BROOMFIELD CITY COUNCIL

Subject: Integra at Broomfield Apartments Concept Review

Integra Land Company has submitted an application for Concept Plan Review for a proposed 312-unit apartment complex, located at 11700 Ridge Parkway. The property is approximately 11.73 acres in size and is generally located south of State Highway 128 and east of Indiana Street.

Conceptual Site Plan

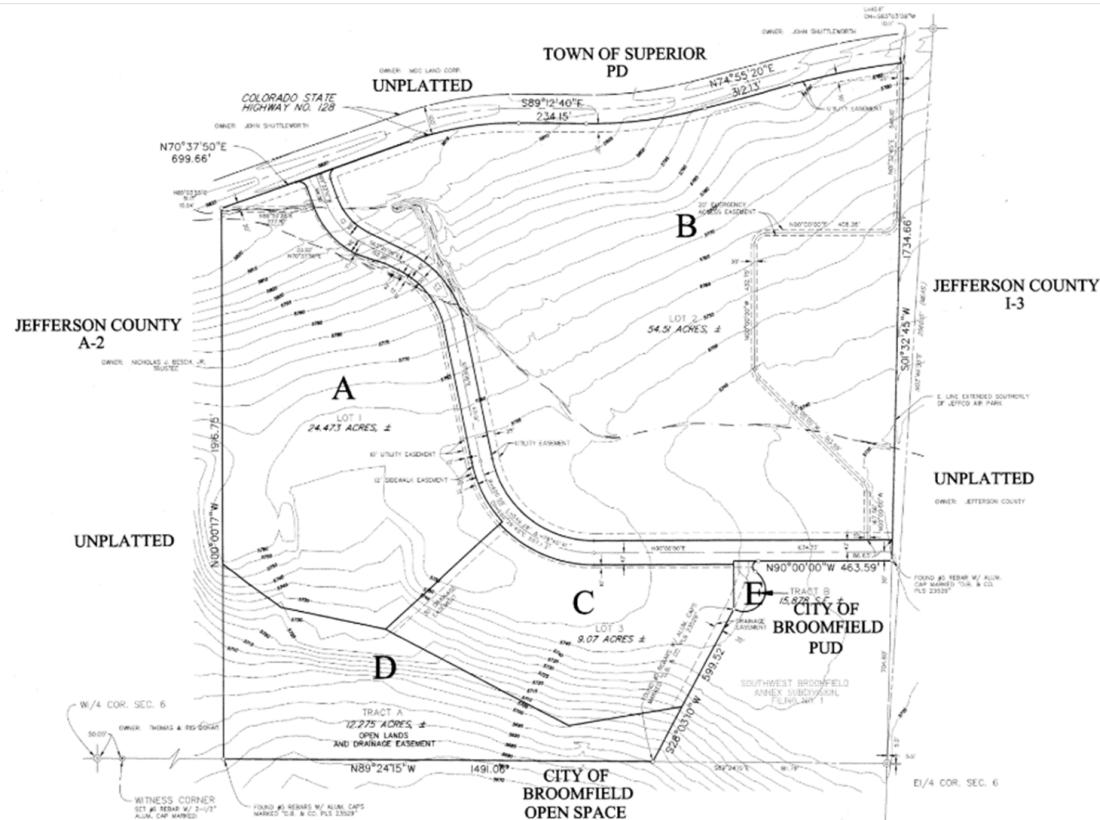
The proposed concept plan depicts six apartment buildings, four carriage house buildings that will house two dwelling units per carriage house building, a pool, a dog park, and a clubhouse. Of the six proposed buildings, four of the apartment buildings are proposed to be four stories high, while two are proposed to be either four or five stories high.

On-lot surface parking is proposed in the center of the proposed development. In addition to the clubhouse, amenities include an outdoor pool and dog park. Landscaping is proposed throughout the site. A single point of access is depicted via Ridge Parkway.

Should this development proceed past the concept plan review stage, a final plat, planned unit development plan amendment, and a site development plan would be required. The PUD Plan amendment for this property would seek to allow an additional 72 residential units, permit residential as a stand-alone use, increase the maximum density per acre from 20 du/ac to approximately 27 du/ac, and increase the maximum height from 50 ft to a 60-70 ft height limit. The proposed unit mix may include the following ratios:
